## CITY of NOVI CITY COUNCIL

### Agenda Item 1 September 24, 2018

**SUBJECT:** Consideration of the request of Orville Properties, LLC for Tentative Approval of Zoning Map Amendment 18.724 for a Planned Rezoning Overlay (PRO) Concept Plan associated with a rezoning from Expo (EXPO) to TC (Town Center). If the City Council determines that it may approve the rezoning with PRO, the City Council shall specify tentative conditions and direct the City Attorney to work with the applicant in the development of a proposed PRO Agreement. Upon completion of the draft PRO Agreement, the City Council shall make a final determination to approve, approve with conditions, or deny the rezoning with PRO. The subject property is approximately 21.48 acres and is located at 43700 Expo Center Drive, north of Grand River Avenue and south of I-96 in Section 15. The applicant is proposing to develop the property as a multi-unit commercial development consisting of nine units accessed by a proposed private drive. The PRO Concept plan includes a request for an Unlisted Use Determination under Section 4.87 of the Zoning Ordinance.

**Figure 1.** City of Novi Regulated Wetland & Woodland Map (approximate property boundary shown in red). Regulated Woodland areas are shown in green and Regulated Wetland areas are shown in blue.

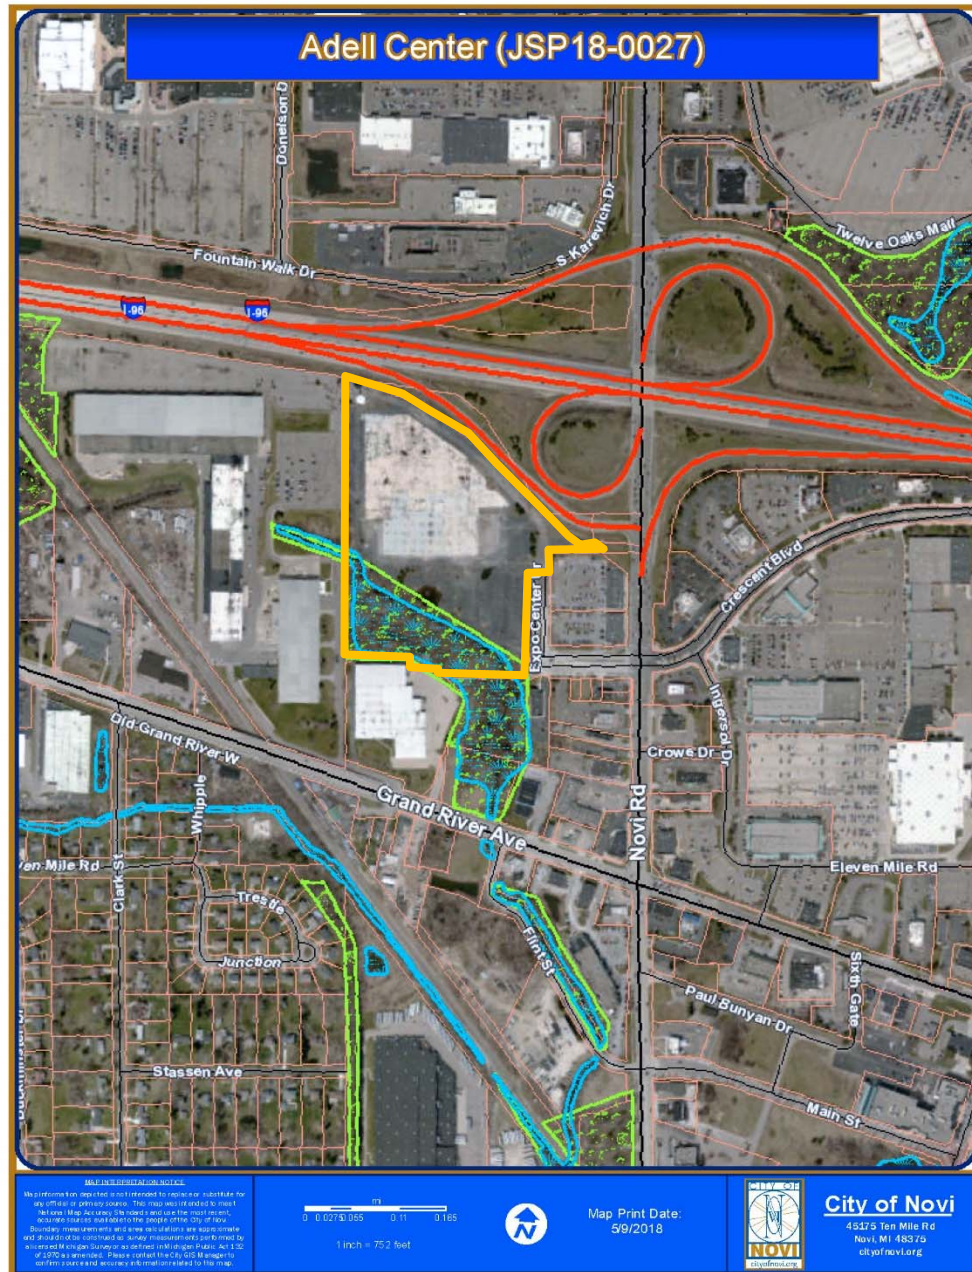
The Site Enhancement Plan includes proposed activity within areas mapped City-Regulated Wetlands/Watercourses and City-Regulated Woodlands on the City's Wetlands and Woodlands Maps (see Figure 1). Six (6) wetland areas and a section of the Walled Lake Branch of the Middle Rouge River as well as City-Regulated woodland are located on the southern section of the subject site. The wetlands appear to be regulated by the City of Novi as well as by the Michigan Department of Environmental Quality (MDEQ).

**REVISED PRO CONCEPT PLAN**

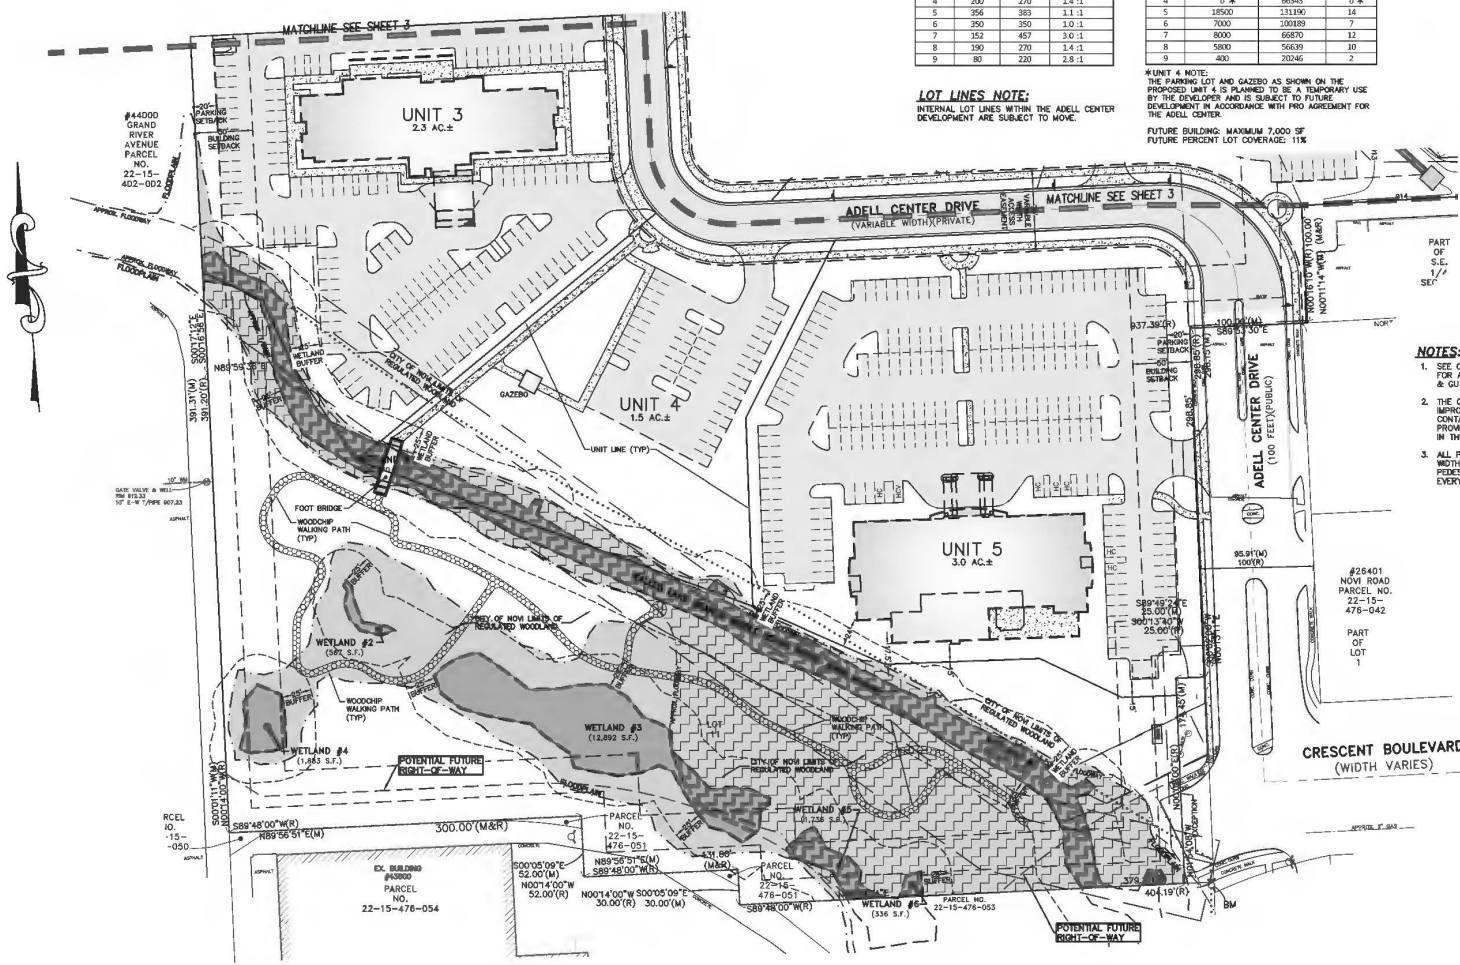
5. Sheet 2 states that the proposed building and parking lot layouts are conceptual only. This is not consistent with the Concept Plan as submitted. **This note shall be removed.** Any notes that refer to the Concept Plan as subject to change at the time of Preliminary Site Plan approval shall be removed from all plans. There are a few notes in the submittal, that refer to possible change to the proposed uses in future, which are not indicated at this time. A note on sheet 02 that refers to "The Users are as of 08-29-18 and will be updated as new users are determined". 'To be determined' refers to an unknown use for which Traffic and other impacts have not been currently identified or reviewed by staff as part of the Concept Plan review. There is a note on sheet 03 and 04 that refers to "Internal lot lines within the Adell Center Development are subject to move". **Staff does not support including these items in a PRO Agreement.**

6. Changes to allowable uses listed on Sheet 2 shall be made as listed below.
7. Regroup as permitted uses and special land uses as listed in Section 3.1.25. Applicant has listed ALL uses in the Town Center Zoning district Permitted and Special Land Uses as listed in Section 3.1.25.B and 3.1.25.C on sheet 02. Listing all of the uses does not meet the intent of the ordinance that uses will be identified on the Concept Plan, as staff and consultants are unable to provide comments on the proposed uses. Staff does not support including these items in a PRO Agreement.

- c. Medical offices and laboratories are not a permitted use under TC district. This item shall be removed; These uses have been removed;
  - d. Last two bullet points on sheet 2 that reference other uses and accessory structures shall be removed; These two bullet points have been removed;

1. The following notes shall be removed from the PRO Concept Plan
  - a. A note on sheet 02 that refers to "The Users are as of 08-29-18 and will be updated as new users are determined".

- b. A note on sheet 03 and 04 that refers to "Internal lot lines within the Adell Center Development are subject to move".
  - c. Building and Parking setbacks provided in a small inset on Sheet 2 as they conflict with the suggested deviations at August 22<sup>nd</sup> Planning Commission meeting;

2. The applicant shall remove the parking reference summary from sheet 02 as the Planning deviation from standards of Sec. 5.12 for up to 5% reduction in minimum required parking will address the counts at the time of respective site plan approval as indicated earlier in this motion sheet;

1. A note shall be added to on Sheet 2, PRO Concept Plan, that each of the uses is subject to Use Standards in Article 4 of Zoning Ordinance;
2. The following notes shall be removed from the PRO Concept Plan

- a. A note on sheet 02 that refers to "The Users are as of 08-29-18 and will be updated as new users are determined".
  - b. A note on sheet 03 and 04 that refers to "Internal lot lines within the Adell Center Development are subject to move".

- c. Building and Parking setbacks provided in a small inset on Sheet 2 as they conflict with the suggested deviations at August 22<sup>nd</sup> Planning Commission meeting;

3. The applicant shall remove the parking reference summary from sheet 02 as the Planning deviation from standards of Sec. 5.12 for up to 5% reduction in minimum required parking will address the counts at the time of respective site plan approval as indicated earlier in this motion sheet;

8. The applicant shall indicate the proposed decorative brick wall on Sheet 2, PRO Concept Plan;
9. The applicant shall develop the road with a three-lane cross-section to further accommodate left-turning activities and provide a wider "buffer zone" for large vehicles entering/exiting the various facilities without entering into the opposing traffic through lane, at the time of Preliminary Site Plan approval;

8. **PRO CONCEPT PLAN:** Sheet 2 states that the proposed building and parking lot layouts are conceptual only. This does not meet the intent of PRO Concept plan. **This note must be removed.** Development and use of the property shall be subject to the more restrictive requirements shown or specified on the PRO Plan. **The applicant should note that the following would possibly require an amendment to the PRO Agreement, unless otherwise agreed upon:**

Sheet 2 states that the proposed building and parking lot layouts are conceptual only. This does not meet the intent of PRO Concept plan. **This note should be removed.** As stated above, development and use of the property shall be subject to the more restrictive requirements shown or specified on the PRO Plan. The applicant should note, any major deviations from the approved PRO plan would possibly require an amendment to the PRO plan.

L-2

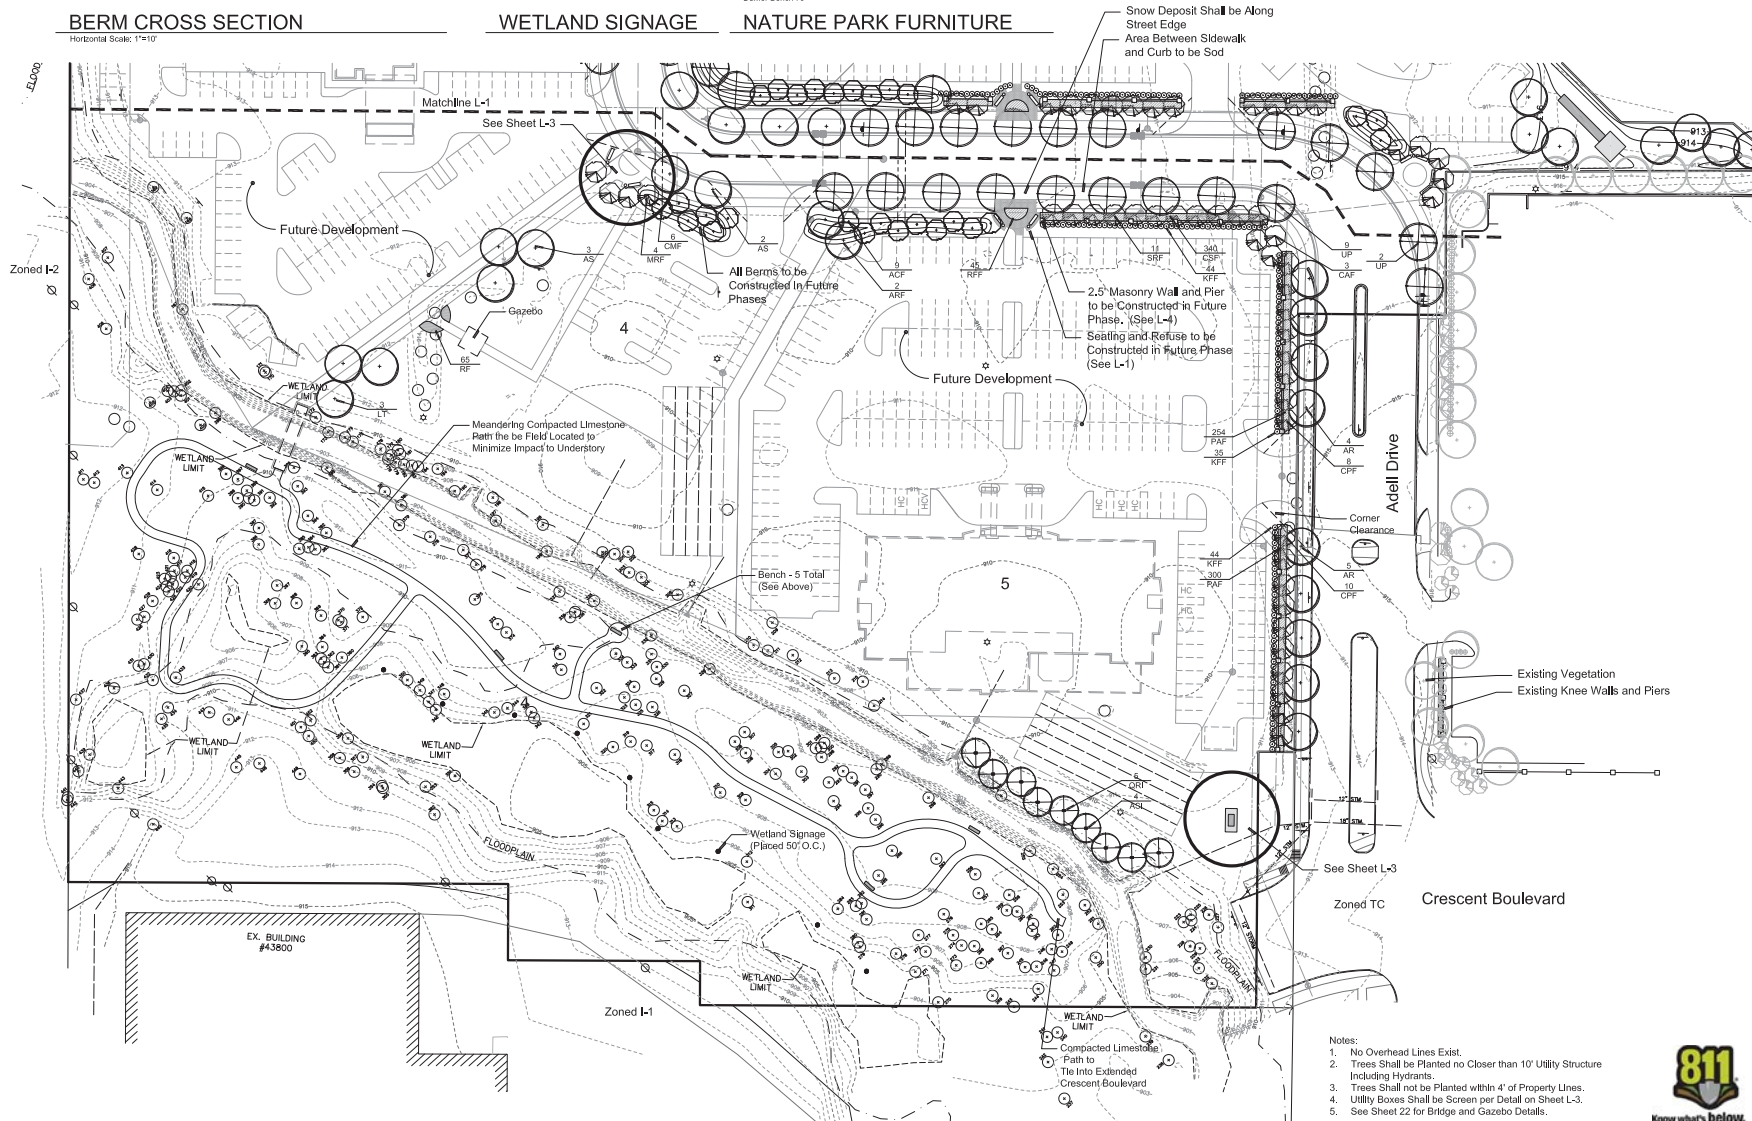
11. The *Landscape Plan Phase 1* (Sheet L-2) notes that wetland signage shall be placed around some of the existing wetland areas at a spacing of 50-feet on-center. The Plan currently indicates that proposed signage will be provided along the northern boundary of Wetland 3 and 5. The applicant should revise the Plan to indicate that conservation easement signage will be provided along all of the existing wetland areas. ECT suggest that the signage be placed at the edge of the 25-foot wetland buffers.

Sheet L-2 includes an example of signage used at a different development within the City of Novi. Subsequent site plan submittals shall provide a signage detail that is specific to the proposed site so that the proposed language can be reviewed/approved.

12. Sheet L-2 (*Landscape Plan Phase 1*) notes that the compacted limestone pedestrian path is to be field located in order to minimize the impact to the regulated woodland area and the understory plants. The path should also be located such that impacts to the existing 25-wetland buffer areas area minimized/avoided.
13. ECT suggests that any proposed stormwater management plan be reviewed by the City of Novi Engineering Department to ensure that they meet the City of Novi design requirements. Specifically,

**Figure 1.** City of Novi Regulated Wetland & Woodland Map (approximate parcel boundary shown in orange). Regulated Woodland areas are shown in green and Regulated Wetland areas are shown in blue.

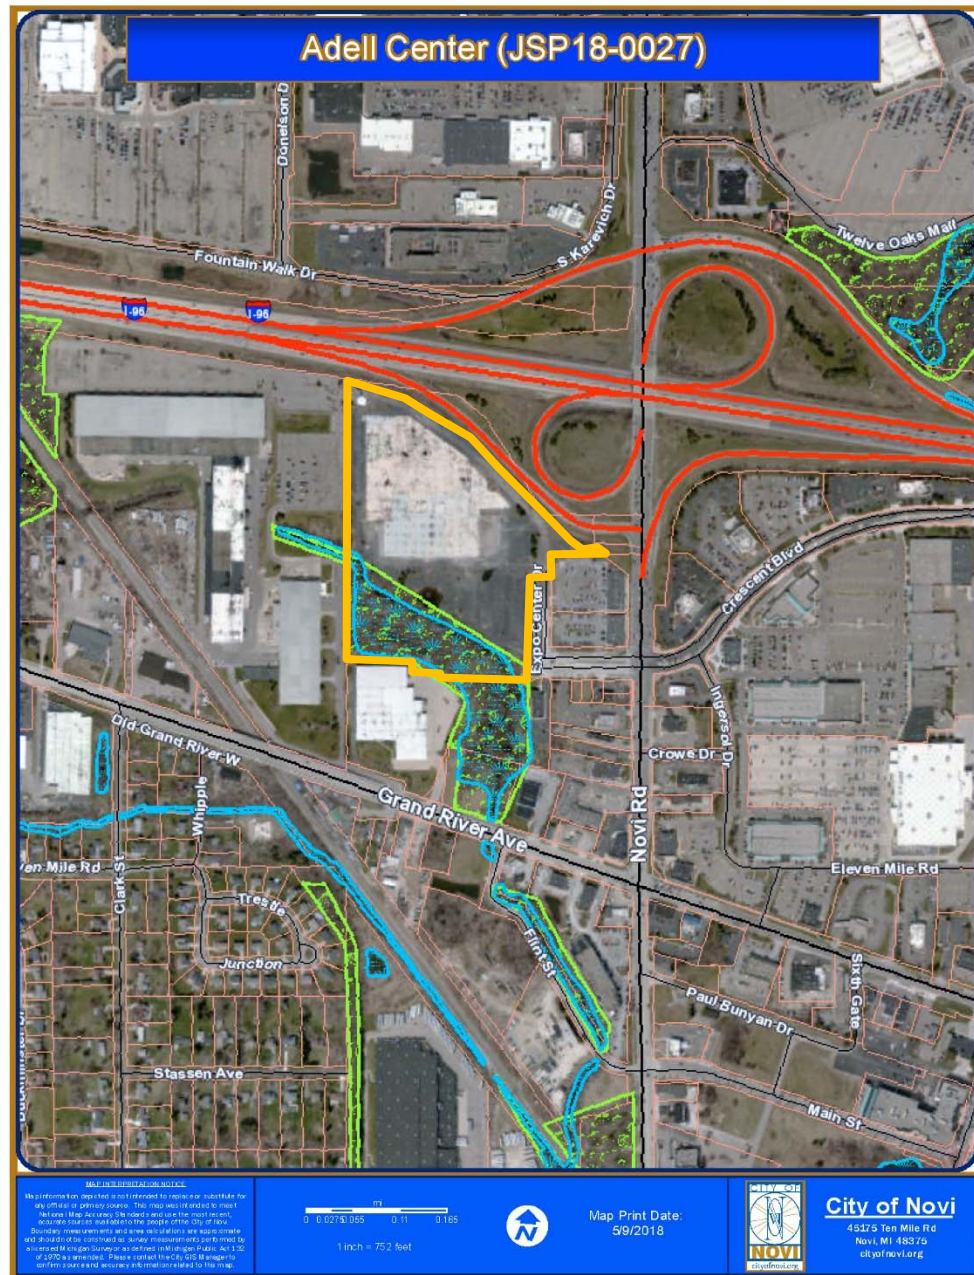
ECT's in-office review of available materials included the City of Novi Regulated Wetland and Watercourse map (see Figure 1), USGS topographic quadrangle map, NRCS soils map, USFWS National Wetland Inventory map, and historical aerial photographs (from Oakland County). Based on our review of this information the overall proposed project parcel contains areas mapped as City-Regulated Wetlands/Watercourses. The site appears to contain wetland/watercourse areas that are regulated by the City of Novi as well as the Michigan Department of Environmental Quality (MDEQ).

Figure 2. Wetland Sketch (provided by BWA).

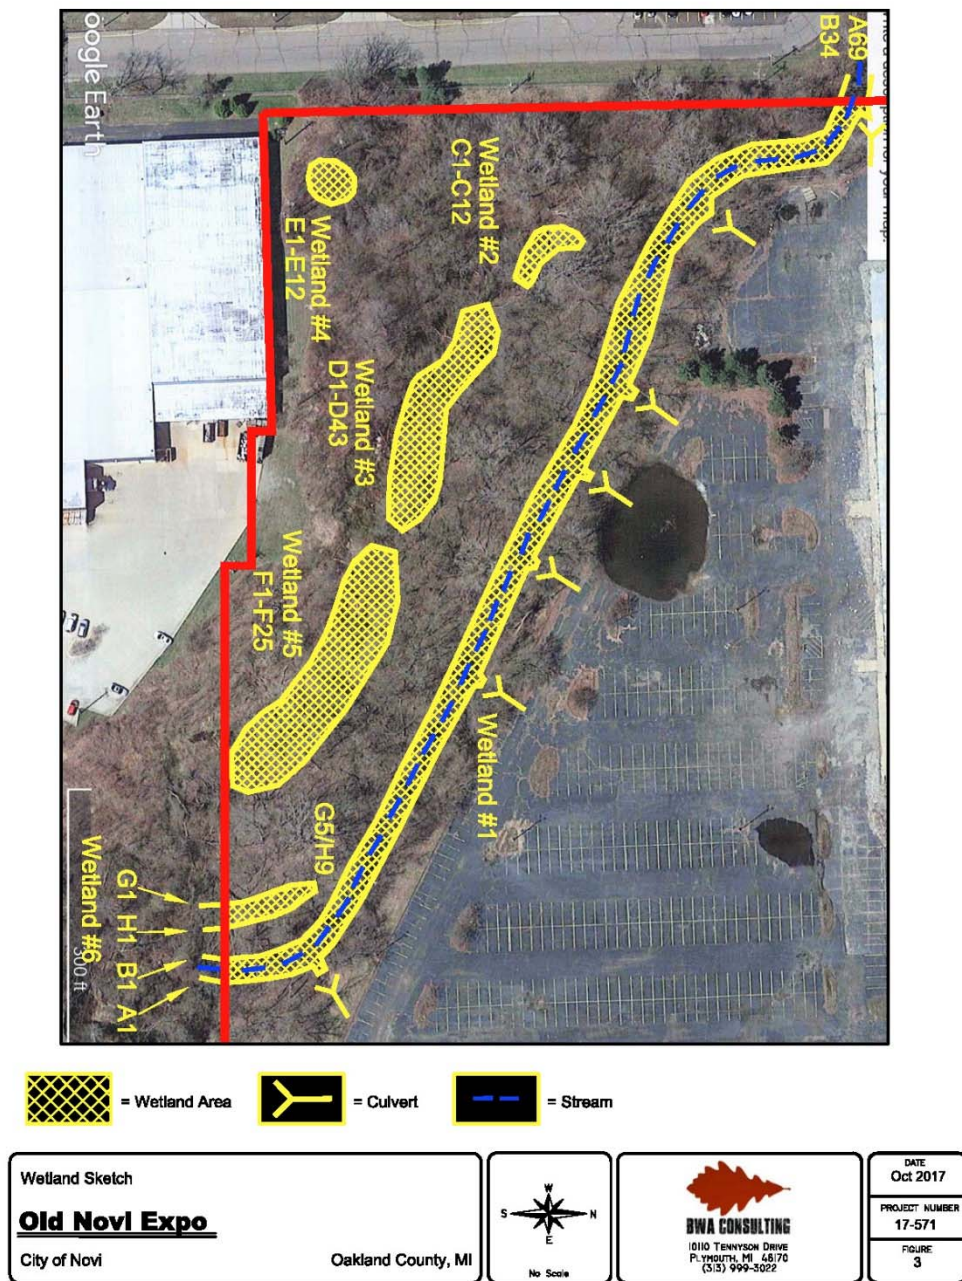
ECT has evaluated the on-site wetlands and believes that they are all considered to be essential/regulated by the City of Novi as they meet one or more of the essentiality criteria (i.e., functions and values) outlined in the City of Novi Wetland and Watercourse Protection Ordinance and regulated by the MDEQ. As noted, the wetlands appear to accurately flagged in the field and appear to be generally indicated accurately on the *Wetland Sketch* provided by BWA (Figure 2, attached).

**Figure 1.** City of Novi Regulated Wetland & Woodland Map (approximate parcel boundary shown in orange). Regulated Woodland areas are shown in green and Regulated Wetland areas are shown in blue.

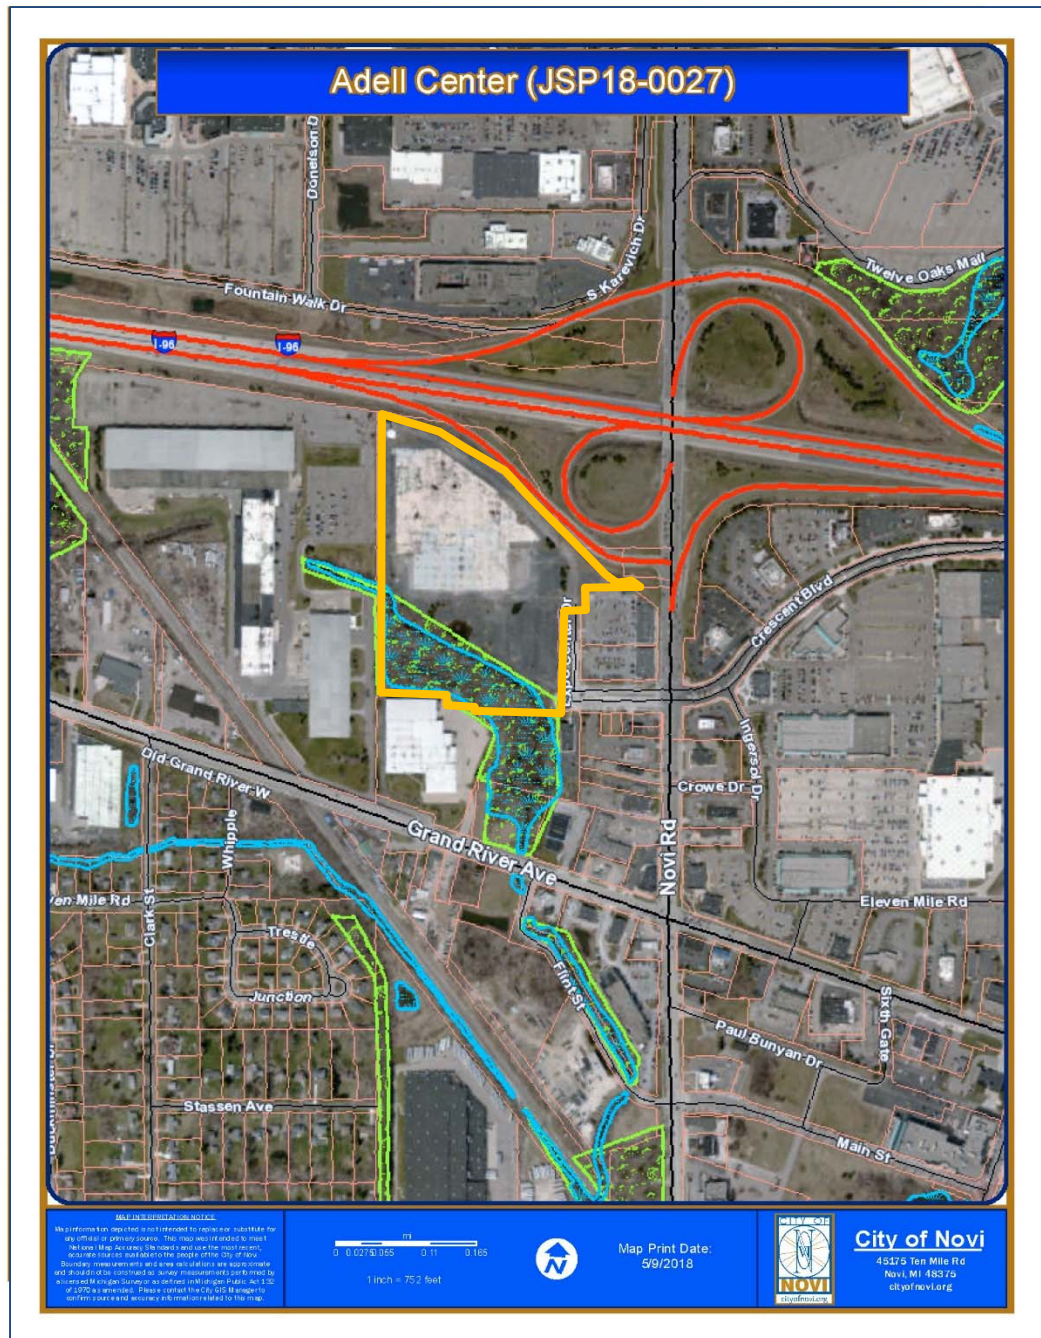
Based on our review of the Plan, Novi aerial photos, Novi GIS, City of Novi Official Wetlands and Woodlands Map (see Figure 1), and on-site evaluation this proposed project site contains areas indicated as Regulated Woodlands as well as Regulated Wetlands. The area of regulated woodland is located in the southern portion of the property (south of the Walled Lake Branch of the Middle Rouge River).
